## Summary of Submissions:

The tables below summarise the comments received during the advertising period of the proposal, together with the Applicant's response to each comment.

Site plan/shadow diagram. Orange shading indicates existing overshadowing, predominantly caused by 2.3m high brick rendered wall contained within Lot 116. Proposed overshadowing in blue shows it'll mostly overlap with existing shadow, or cast over the roof of adjoining dwelling on Lot 116.

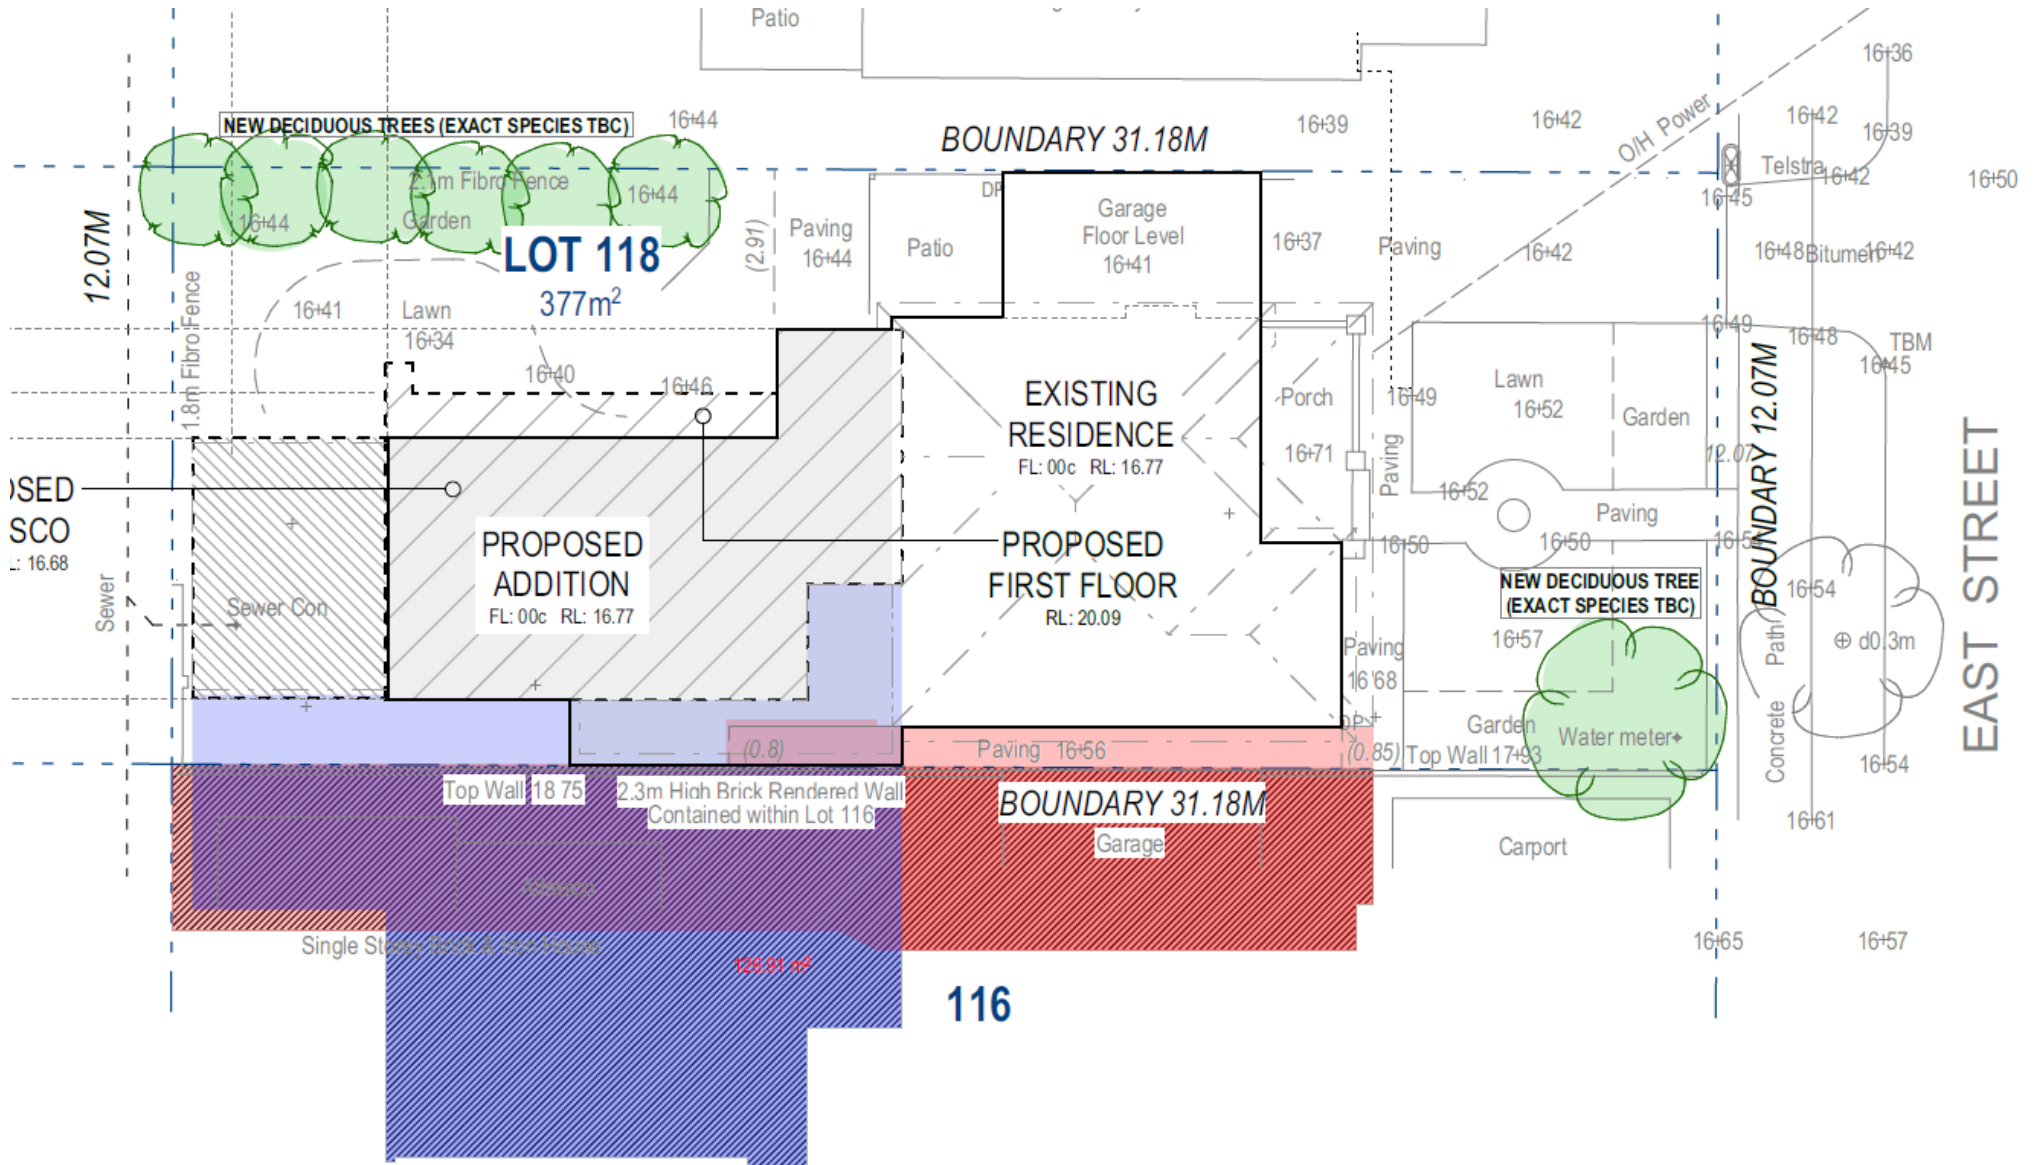
Comments Received in Objection:	Applicant Comment:
<p><u>Open Space</u></p> <ul style="list-style-type: none"> <li>The lack of open space reduces the ability for future landscaping and planting</li> </ul>	<ul style="list-style-type: none"> <li>Site coverage is compliant with R-codes and LPS.</li> <li>Tree planting proposed along Northern boundary, as well as within front setback.</li> <li>Proposal achieves over 60% open space, that is 15% more than the minimum 45% required by the Residential Codes of WA, Table 1.</li> </ul>
<p><u>Lot Boundary Setbacks</u></p> <ul style="list-style-type: none"> <li>The building bulk of the development encroaches onto other properties</li> <li>The two-storey box design is significantly imposing to single story homes adjacent</li> <li>The reduced setbacks result in loss of sunlight to adjoining properties as well as reduced ventilation</li> <li>The reduced setbacks affect the outlook from the neighbouring backyards and windows</li> <li>Boundary wall heights will provide building bulk impacts to adjoining properties and reduce sunlight</li> <li>The reduced setbacks will set a negative precedence for future developments in the area.</li> </ul>	<ul style="list-style-type: none"> <li>South-elevation has been amended with increased setback and more articulation following comments from DRP chair and meeting with Scout Walsh.</li> <li>As demonstrated on shadow diagram, existing boundary wall on adjoining lot 116 already overshadows the courtyard.</li> <li>Height and setback of the 2-storey element are compliant.</li> <li>The element that constitutes "reduced setback" only refers to the lower portion of the wall, which is almost completely screened by the boundary wall on the adjoining lot. The upper floor portion is fully compliant. This is outlined and discussed in the letter of justification included in our initial submission.</li> <li>Please refer to shadow diagram and photographs included on the last few pages.</li> </ul>
